Access Compliance Report Public Rights-of-Way (Curb Ramps)

Main Street: HYDRANGEA_ST		Cross Street: S_SELLAS_RD		Location:	SW
ADA ID: RPAT211102131935	Ramp Type:Type 1 - Perpendicular Diagonal Initial Pass/Fail: Fail		Overall Compliance: No	Severity Score:	16
Codes/Mitigation Info/Possible Solution			Field Measurements/Component Compliance

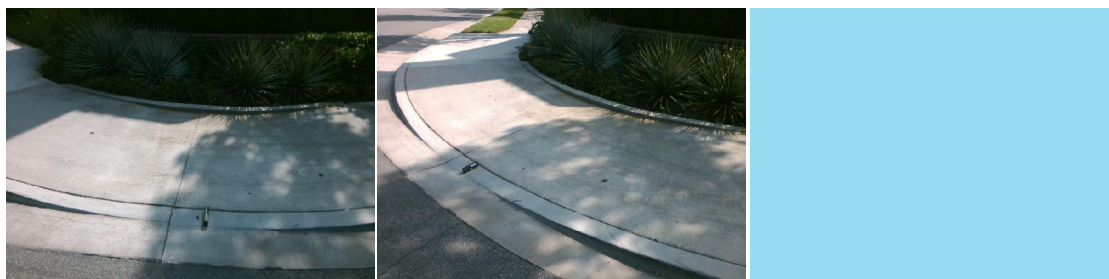
R304.2.2, R204.3, STD 1115

Remove & Replace Curb Ramp With Two New Directional Ramps or Equivalent.
